2025 GROUP B PROPOSED CHANGES TO THE I-CODES

April 27 – May 6, 2025
Doubletree by Hilton
Universal Orlando - Orlando, FL

Publication Date: March 2025

FIGURE R602.6(1) NOTCHING AND BORED HOLE LIMITATIONS FOR EXTERIOR WALLS AND BEARING WALLS

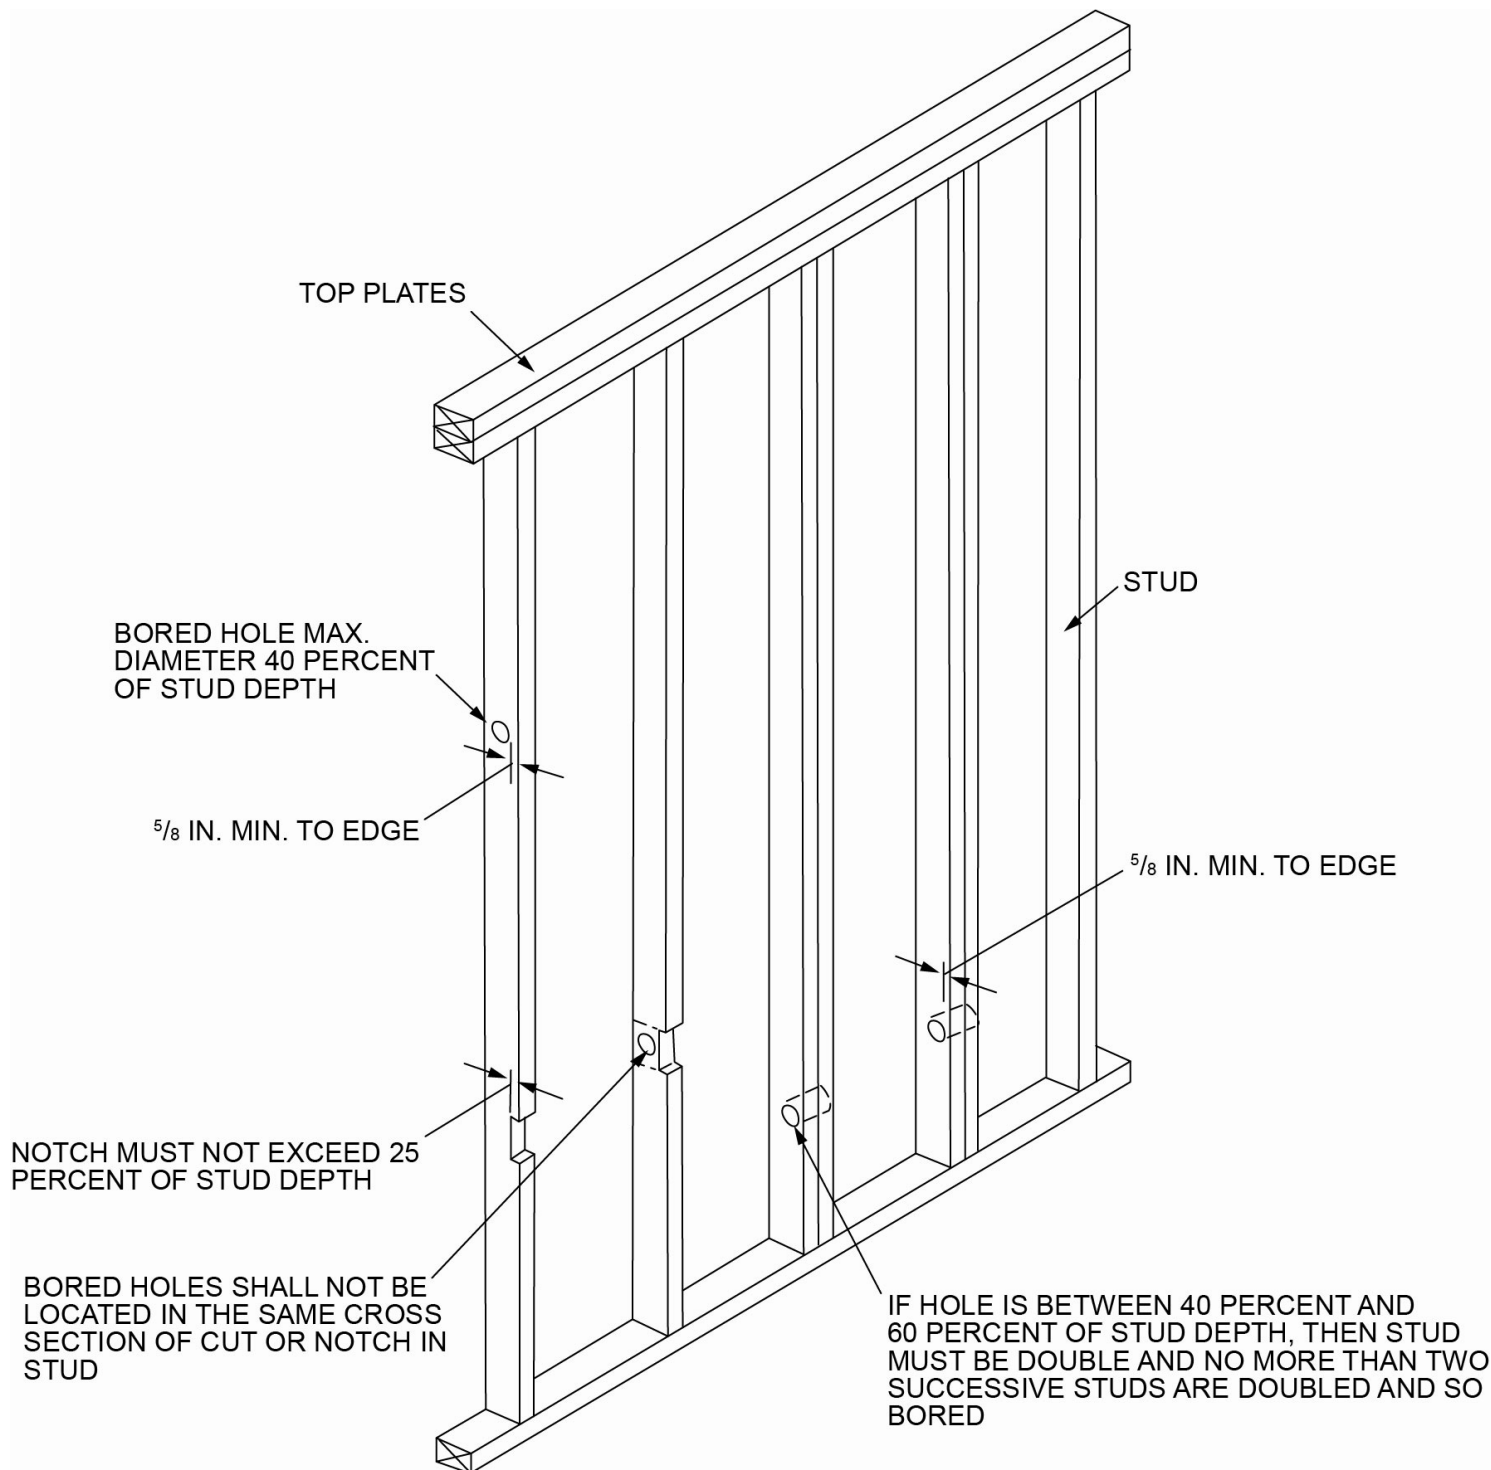
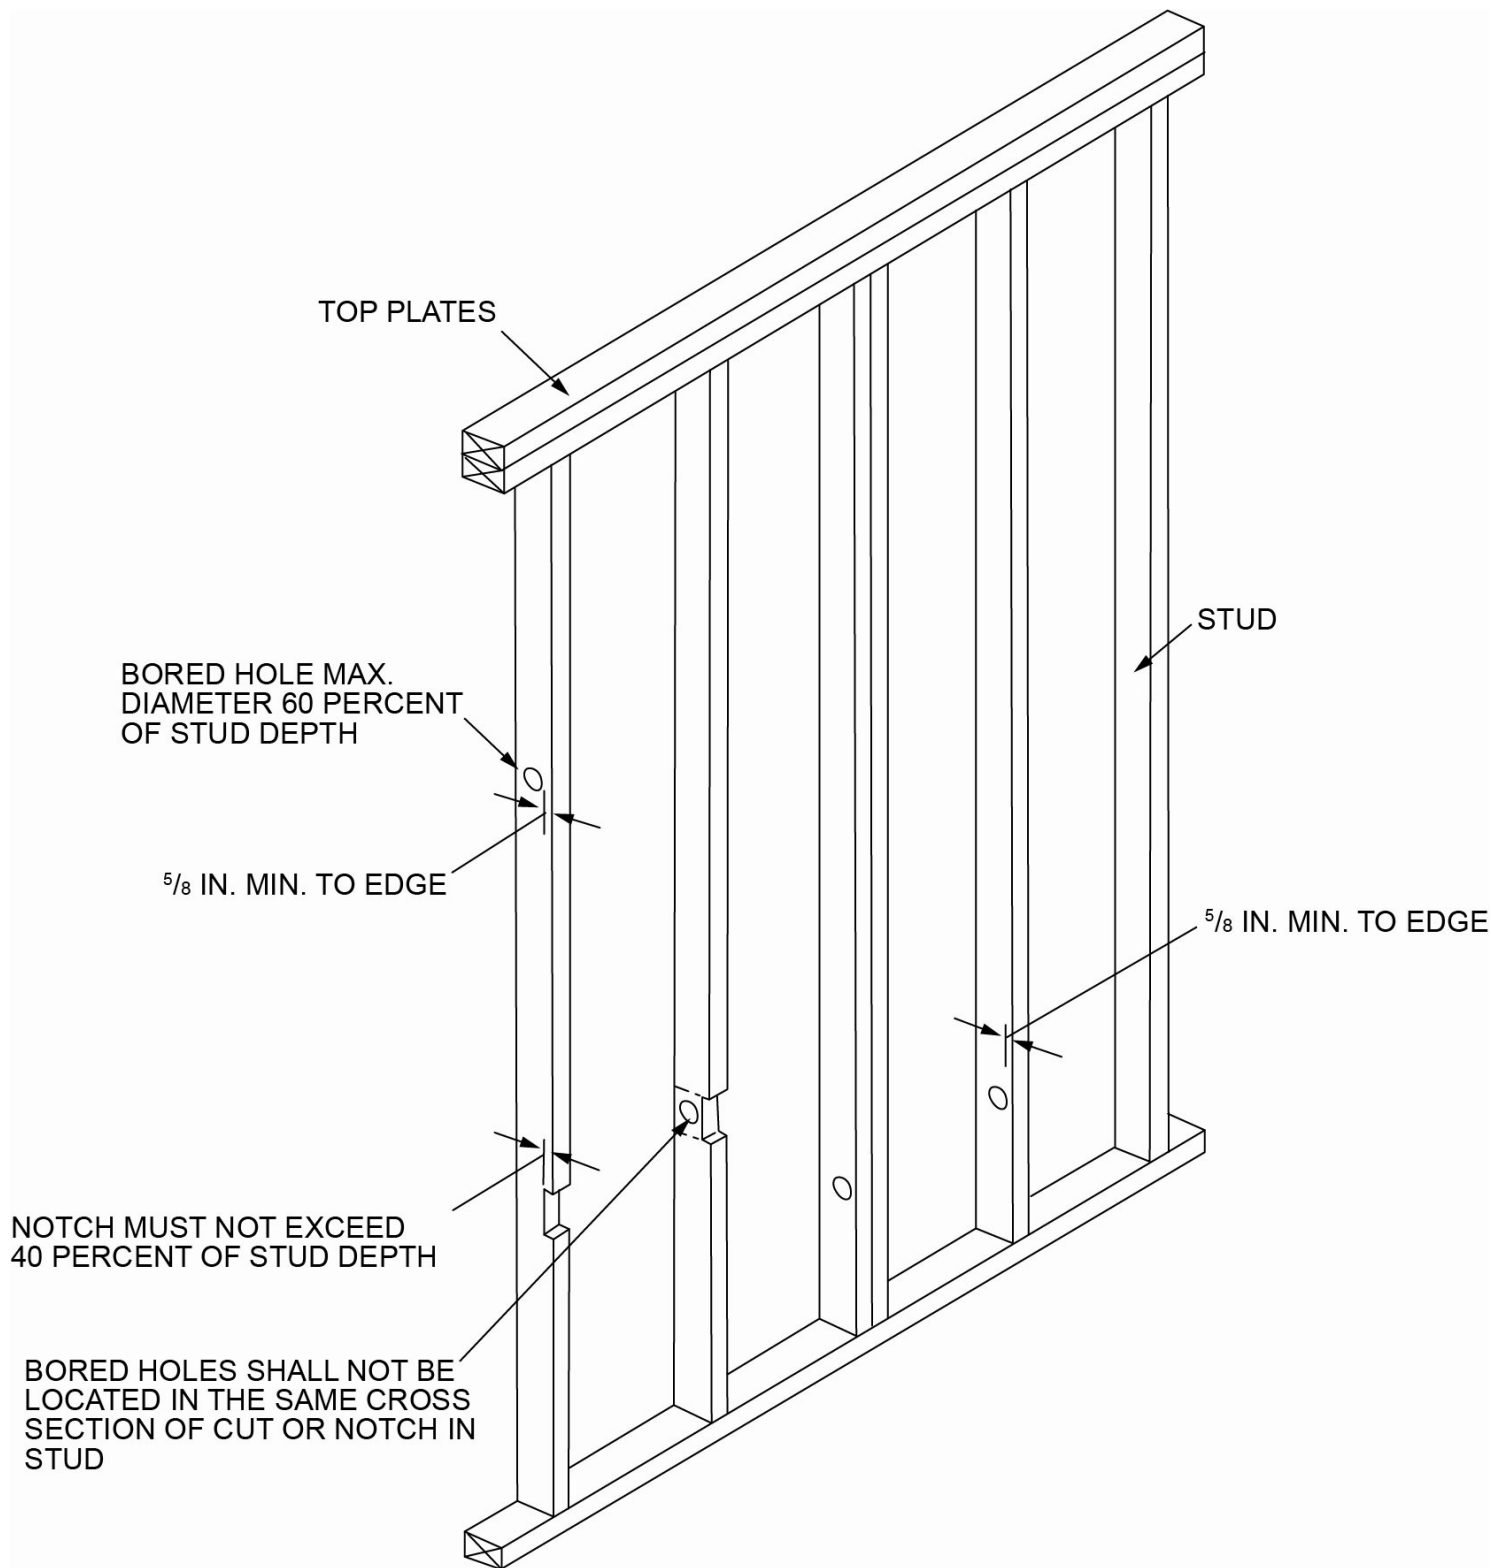
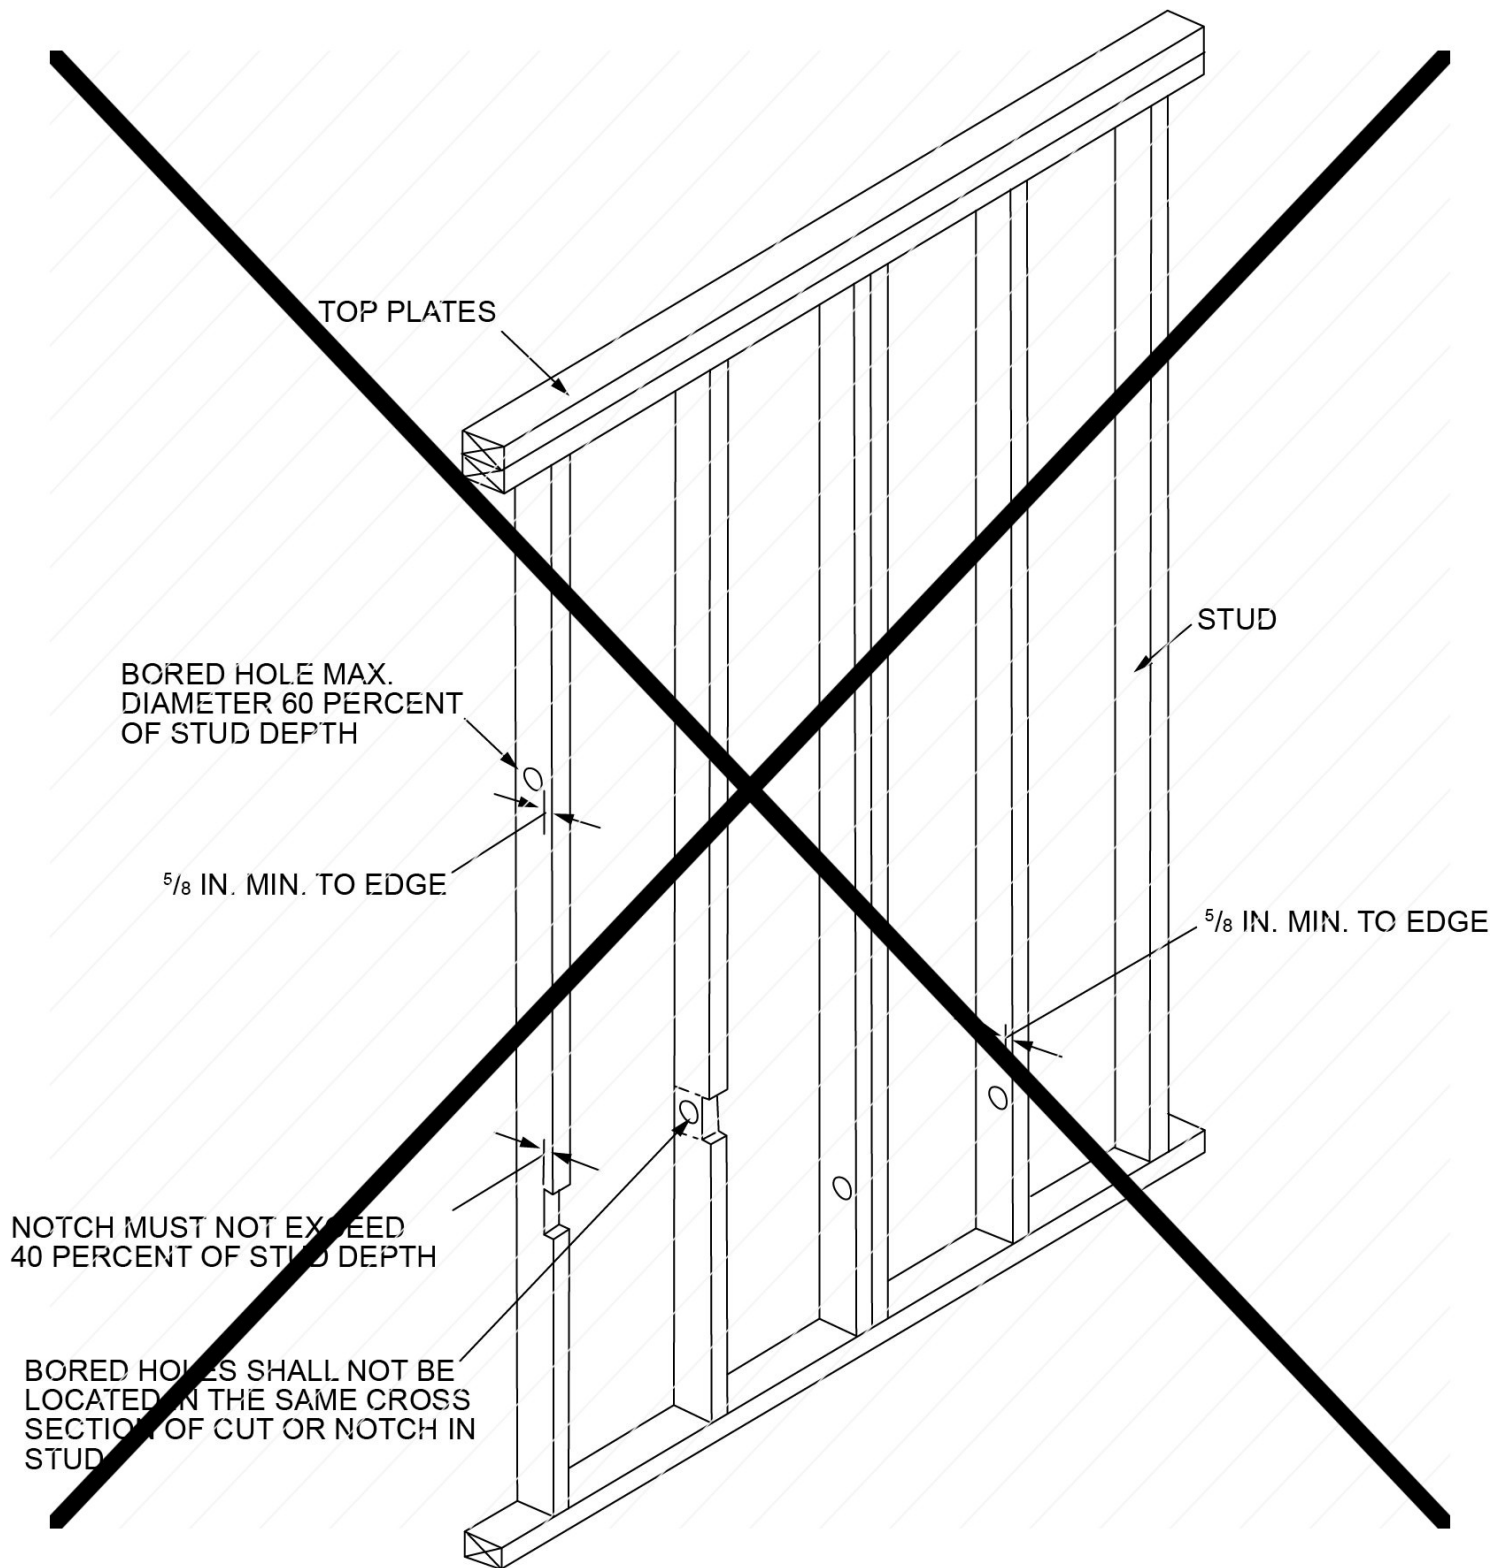
1. Notching. A stud in an exterior wall or interior load-bearing wall ~~bearing partition~~ shall not be cut or notched to a depth exceeding 25 percent of its depth. Studs in nonbearing interior walls ~~partitions~~ shall not be notched to a depth exceeding 40 percent of a single stud depth.
2. Boring. The diameter of bored holes in studs shall not exceed 60 percent of the stud depth, the edge of the hole shall not be less than ⁵/₈ inch (16 mm) from the edge of the stud, and the hole shall not be located in the same section as a cut or notch. Where the diameter of a bored hole in a stud located in exterior walls or interior load-bearing walls ~~bearing partitions~~ is over 40 percent, such stud shall be doubled and not more than two successive doubled studs shall be so bored. See Figures R602.6(1) and R602.6(2).

FIGURE R502.8 CUTTING, NOTCHING AND DRILLING

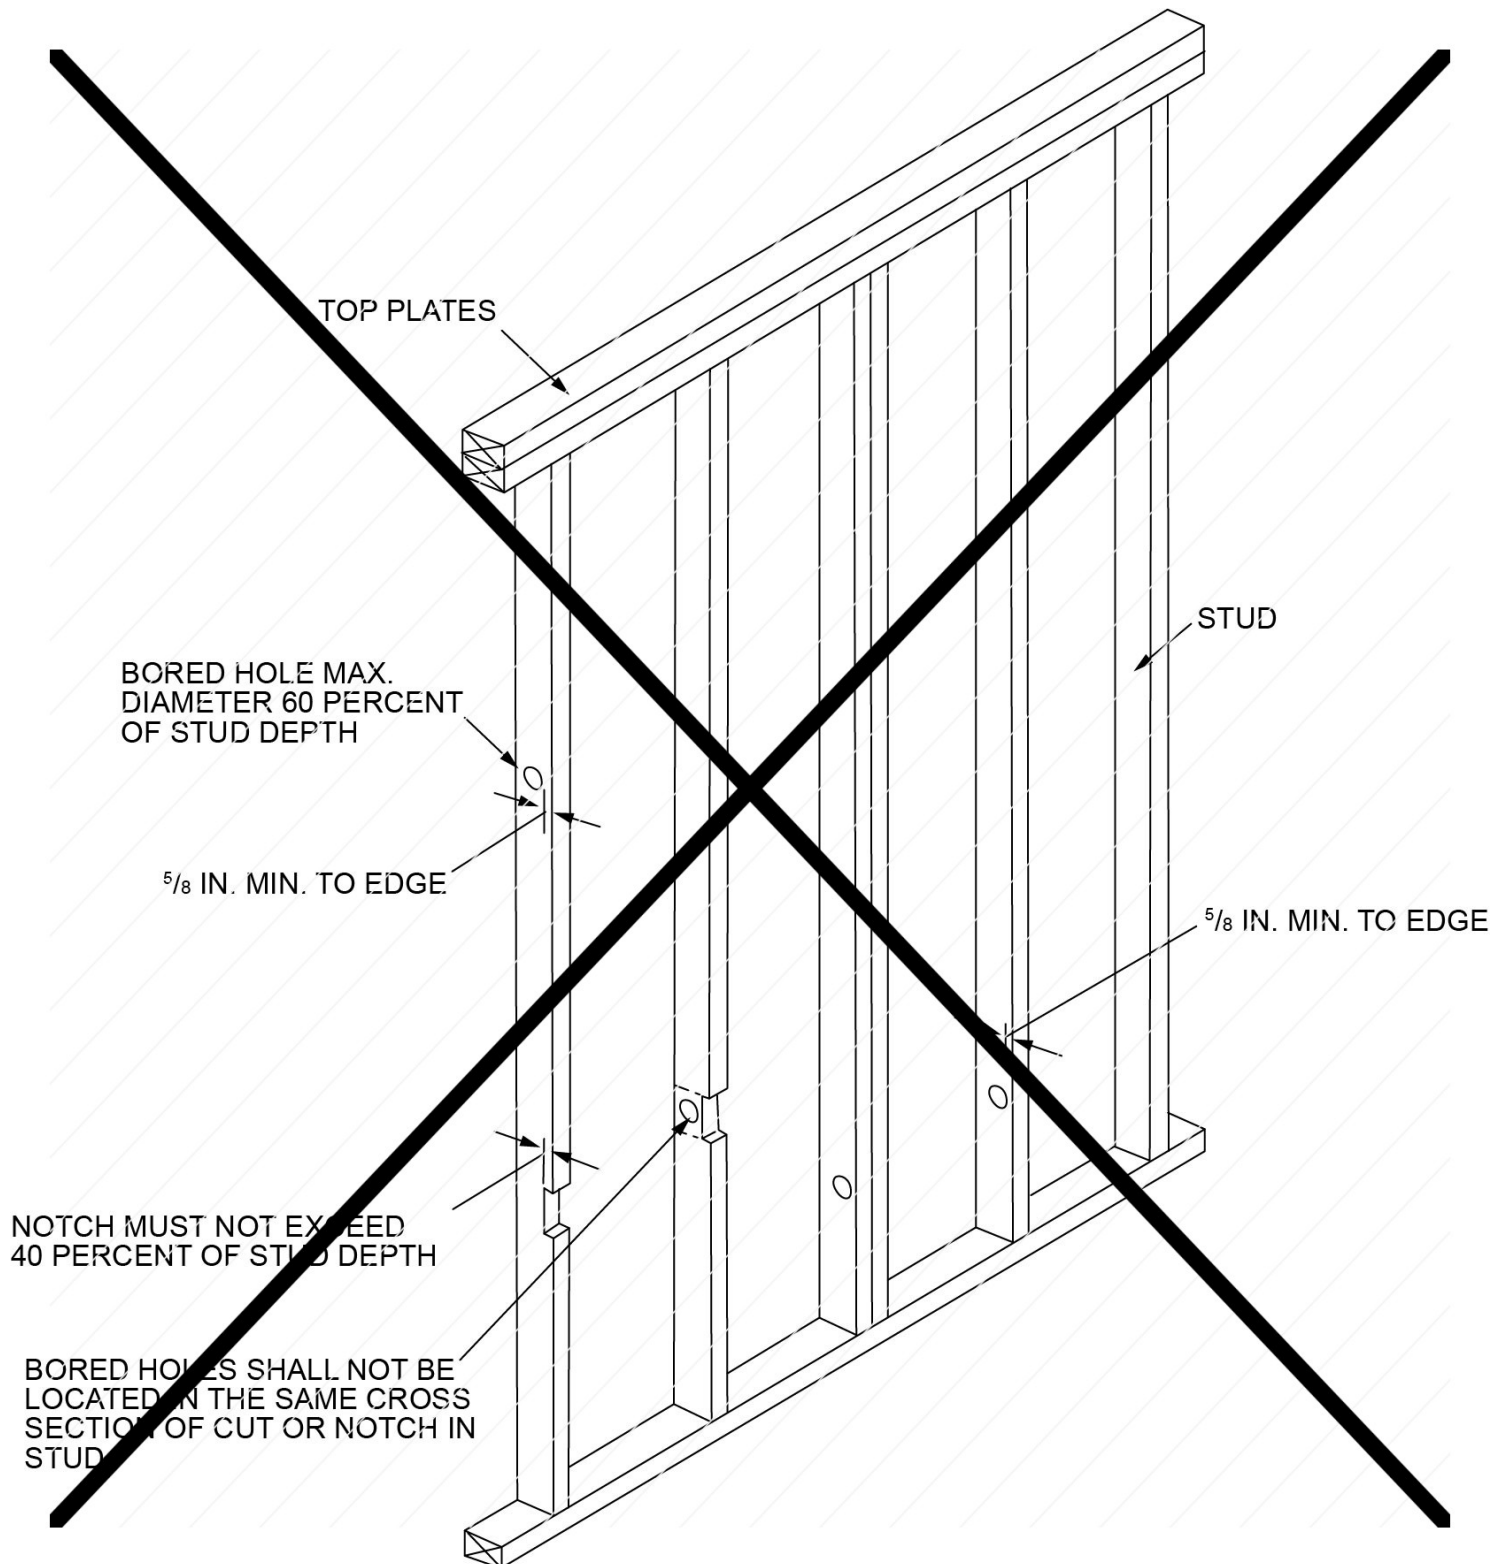
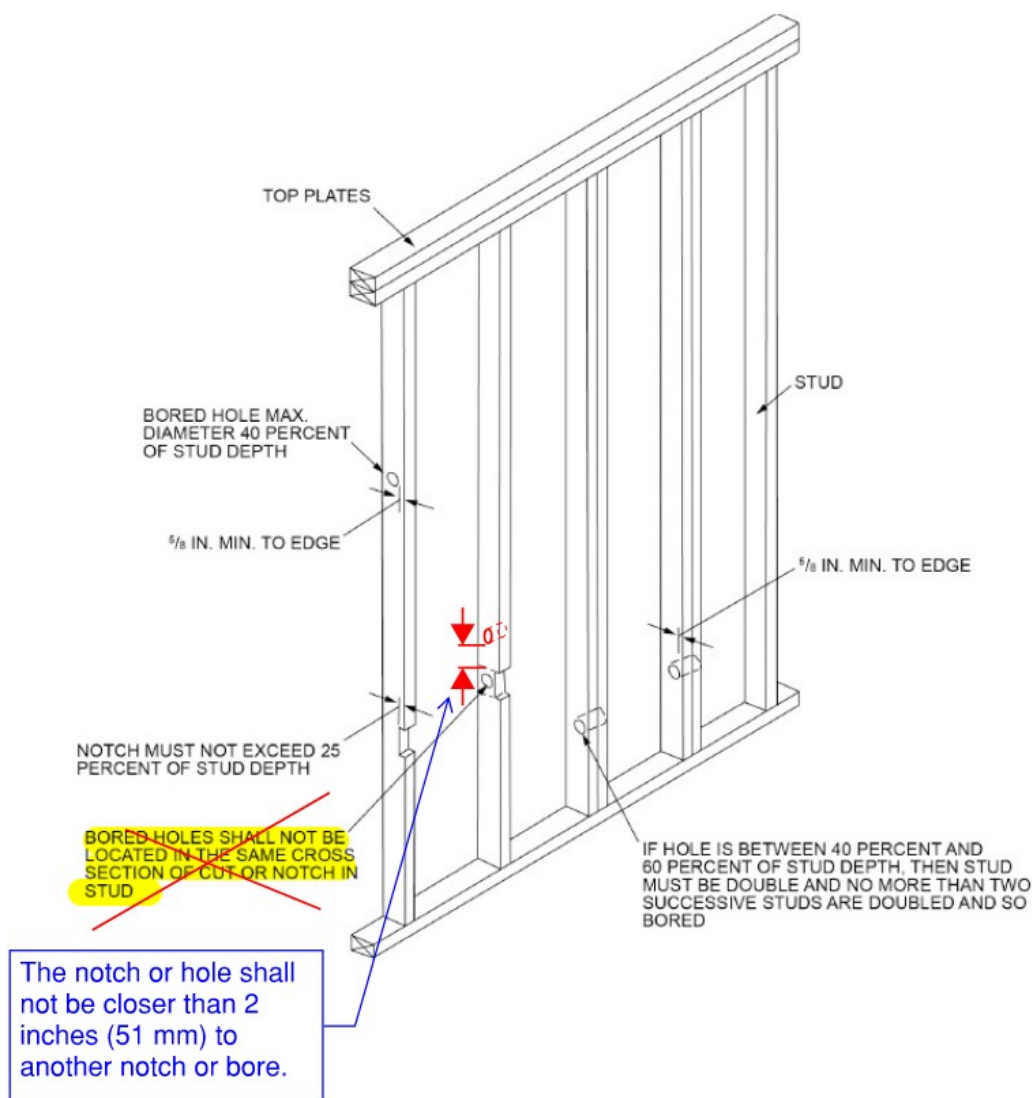
R502.8.1 Sawn lumber. Notches in solid lumber joists, rafters and beams shall not exceed one-sixth of the depth of the member, shall not be longer than one-third of the depth of the member and shall not be located in the middle one-third of the span. Notches at the ends of the member shall not exceed one-fourth the depth of the member. The tension side of members 4 inches (102 mm) or greater in nominal thickness shall not be notched except at the ends of the members. The diameter of holes bored or cut into members shall not exceed one-third the depth of the member. Holes shall not be closer than 2 inches (51 mm) to the top or bottom of the member, or to any other hole located in the member. Where the member is notched or bored, the notch or hole shall not be closer than 2 inches (51 mm) to ~~the another~~ notch or bore.
